PSE&G Public Service
Electric and Gas
Company

September 26, 1984

HOPE CREEK GENERATING STATION
DOCKET NO. 50-354
DRAFT SAFETY EVALUATION REPORT
OPEN ITEM STATUS

PENETRATION CONDUCTOR
 OVERCURRENT PROTECTION

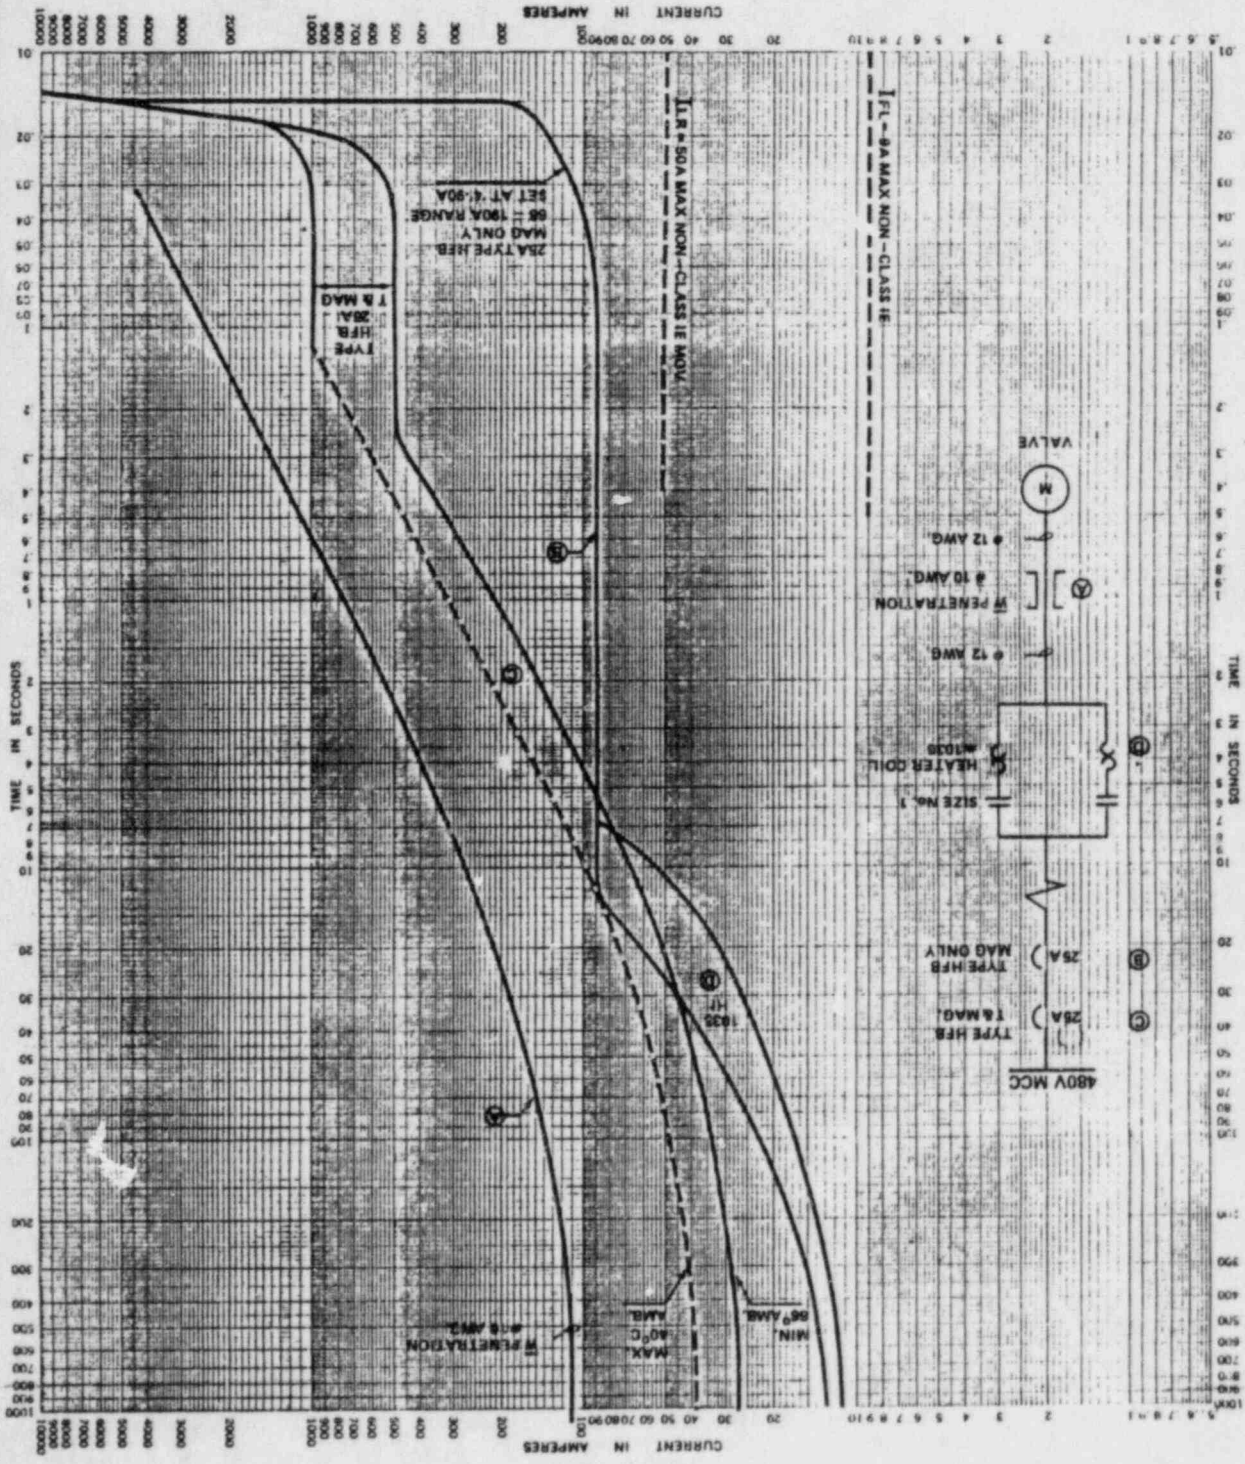
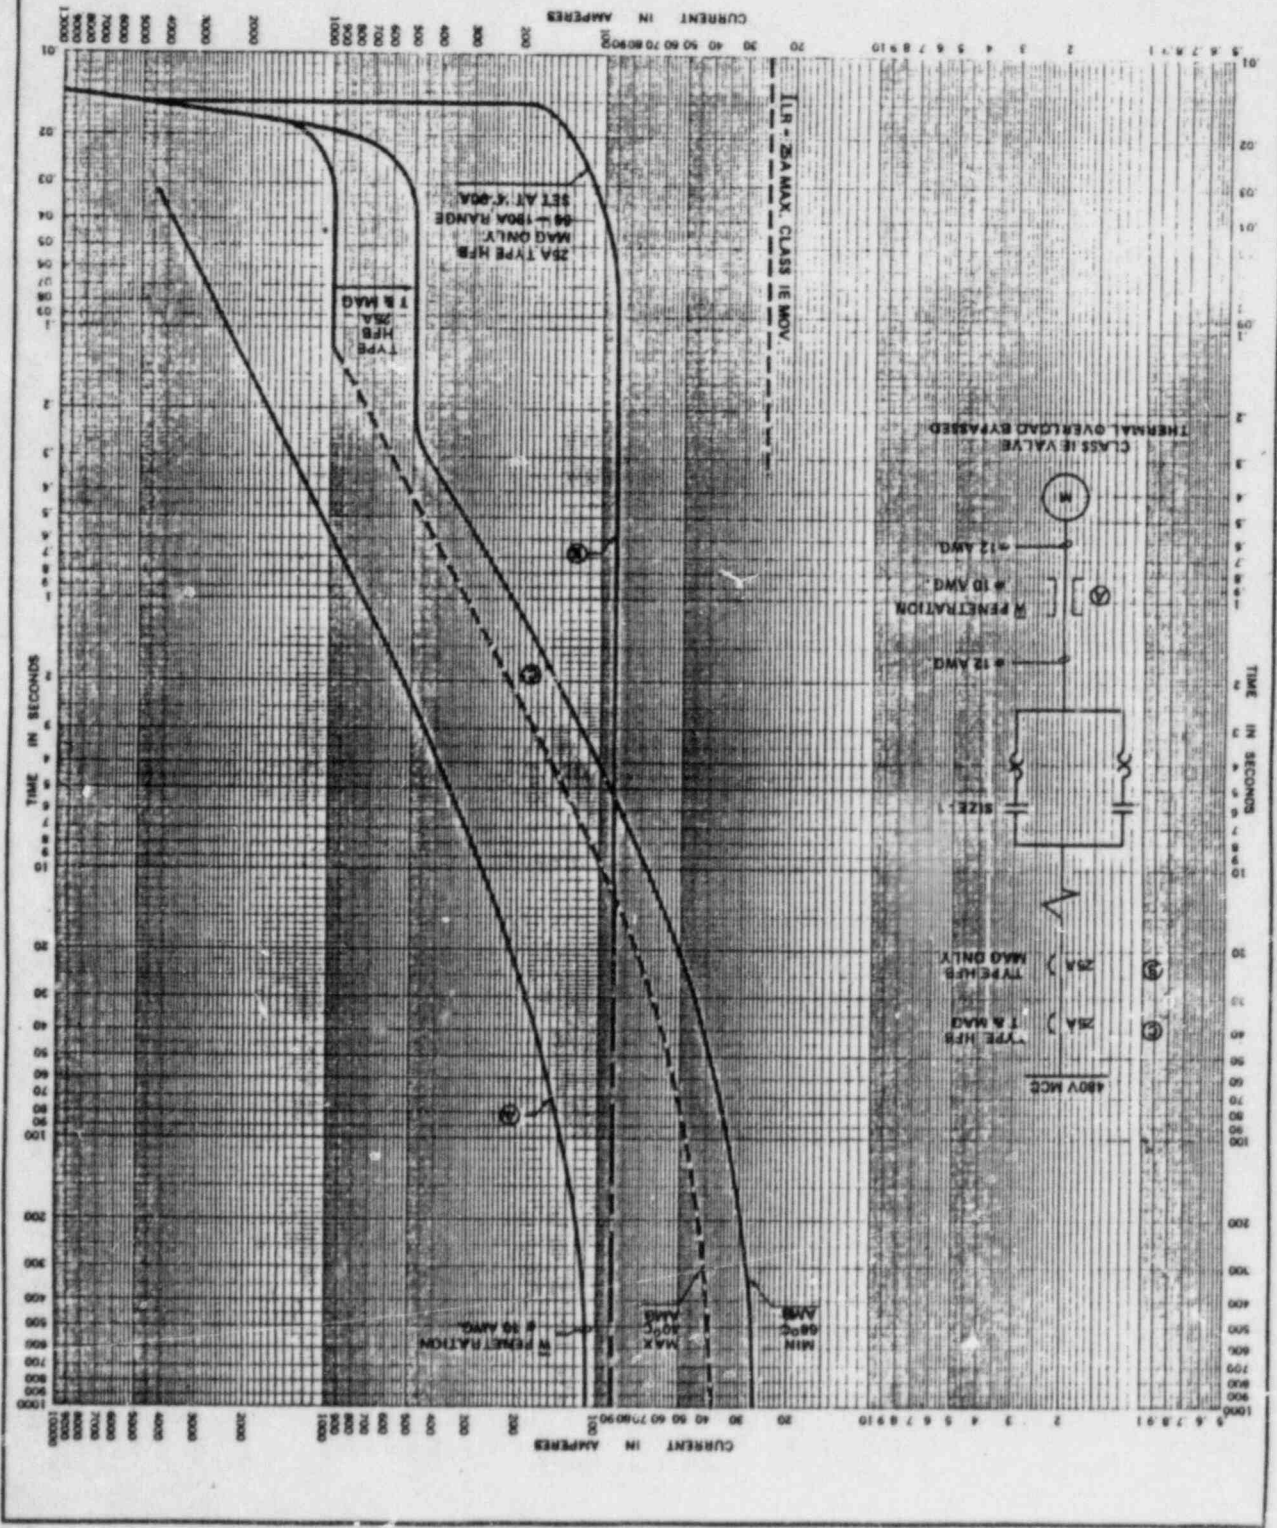
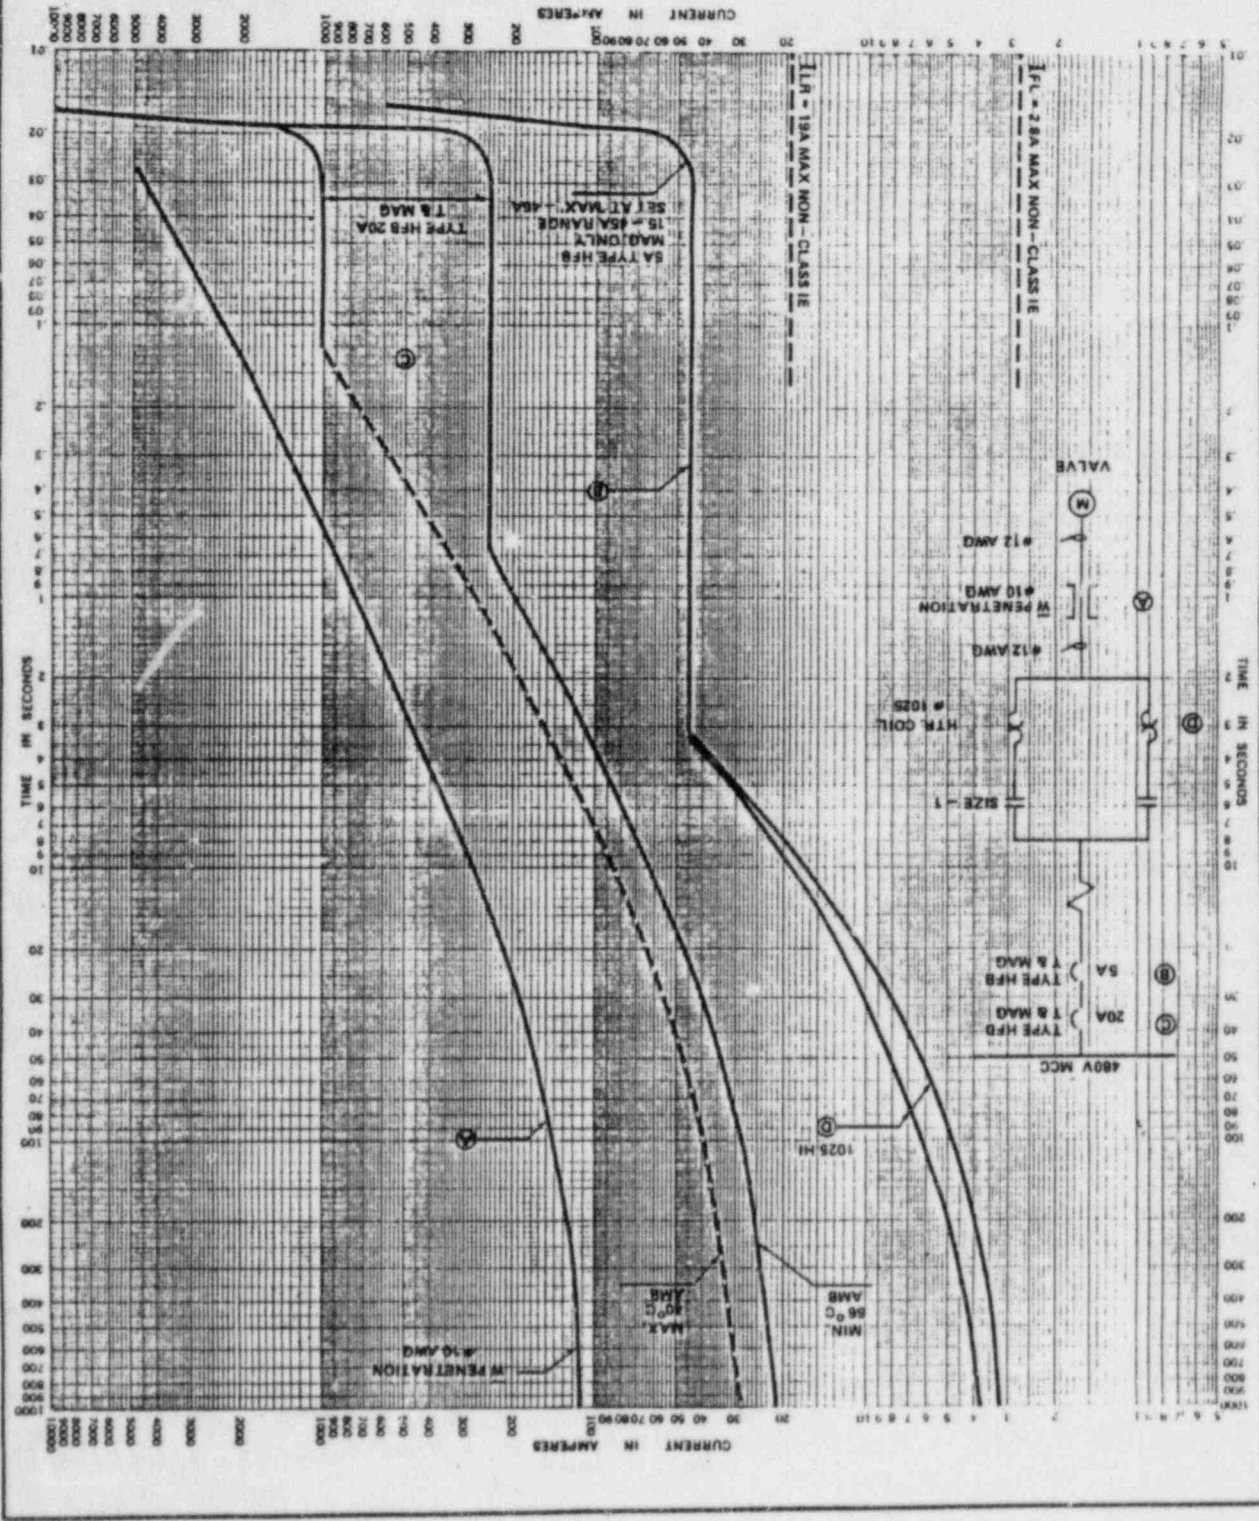
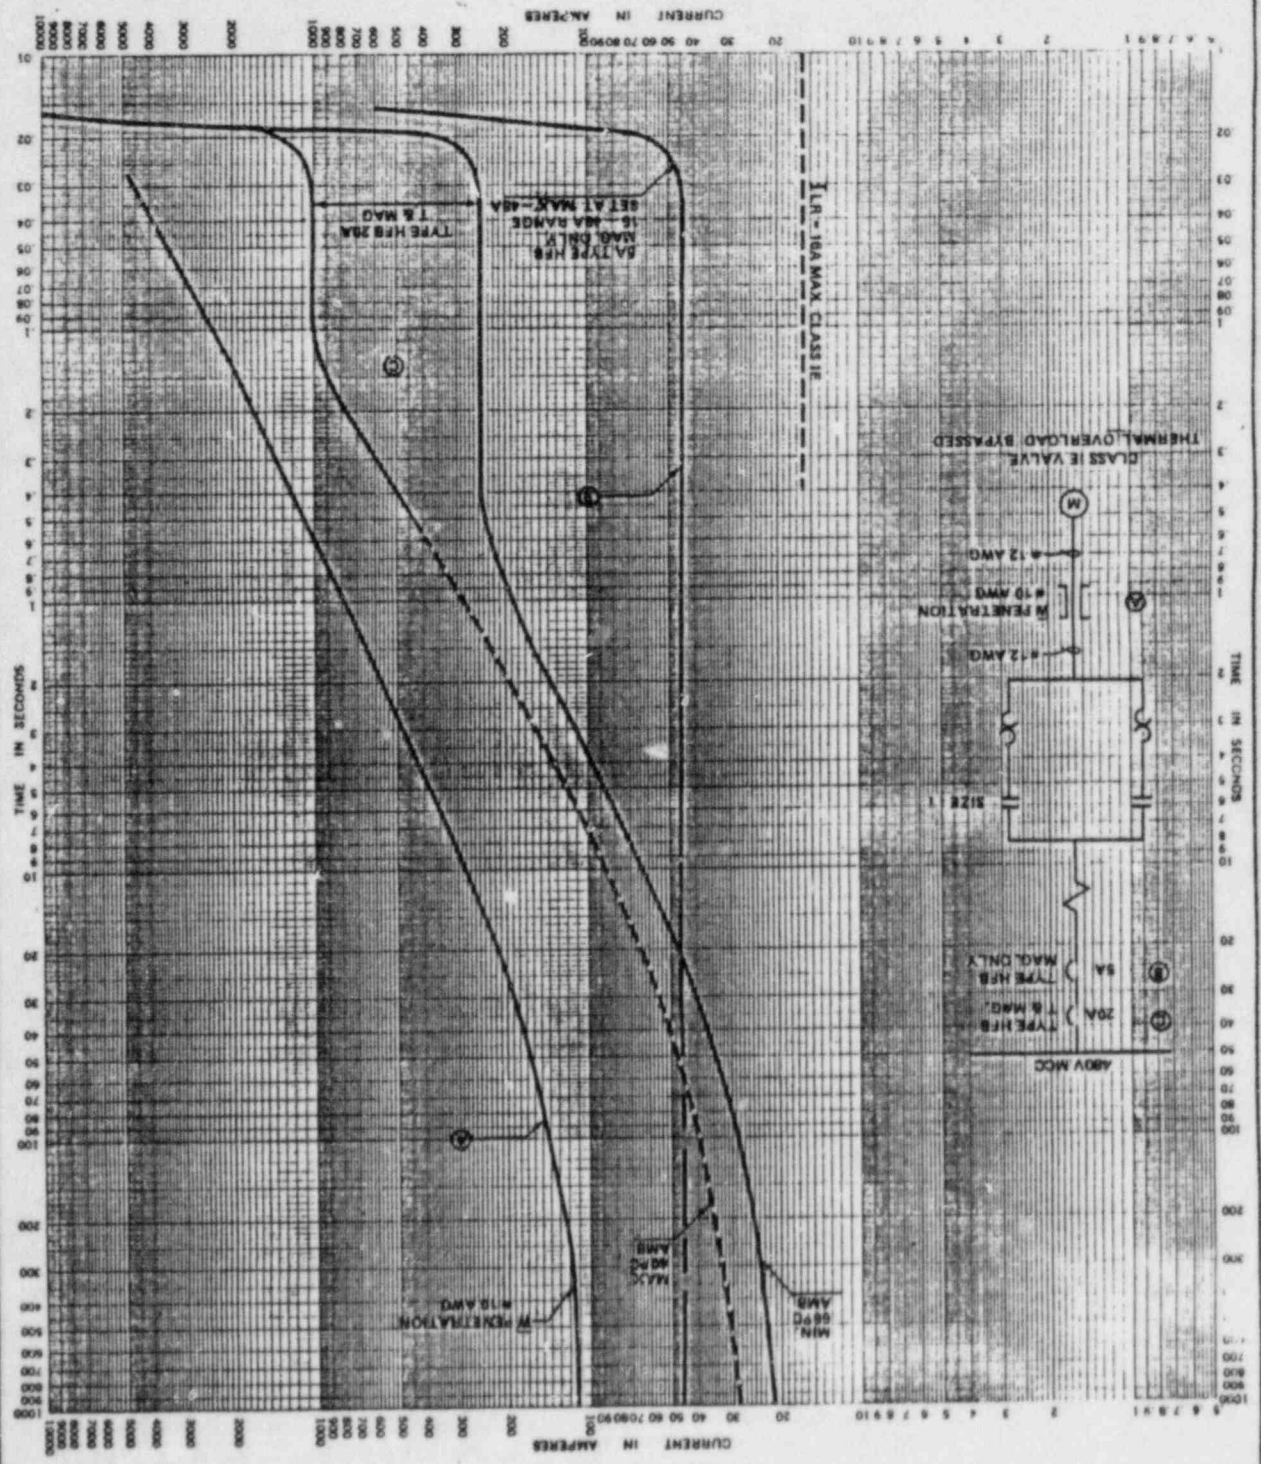
By Amendment 4 to the FSAR, the applicant indicated that coordinated fault-current versus time curves for representative penetration conductors and their protective devices are included in Figures 420.46-1 of the FSAR. Based on a review of these figures, the staff concludes that representative curves for motor differential relay, current transformer, and instrumentation circuits were not included in Figure 430.46-1. Inclusion of these circuits as well as other circuits such that the coordinated fault-current versus time curves is representative of all penetration circuits will be pursued with the applicant.

In addition, the penetration assemblies are designed to withstand, without loss of mechanical integrity, the maximum short-circuit current vs. time conditions that could occur, given single random failures of circuit overload protection devices. Time current characteristic curves, based on tests, of the penetration conductors have been established by the penetration supplier; these curves show the maximum duration of symmetrical short circuit current. Based on these curves the primary and backup protective devices are selected to ensure that the mechanical integrity of the penetrations is maintained. Coordinated fault-current versus time curves for representative penetration conductors and the protective devices are shown in Figures 8.3-17, Sheets 1 to 22.

The test report that substantiates the capability of the electrical penetration to withstand fault current without seal failure for worst case environmental conditions has been submitted under a separate cover.

The testing of all penetration over-current protective devices will be incorporated in the HCGS Technical Specifications.
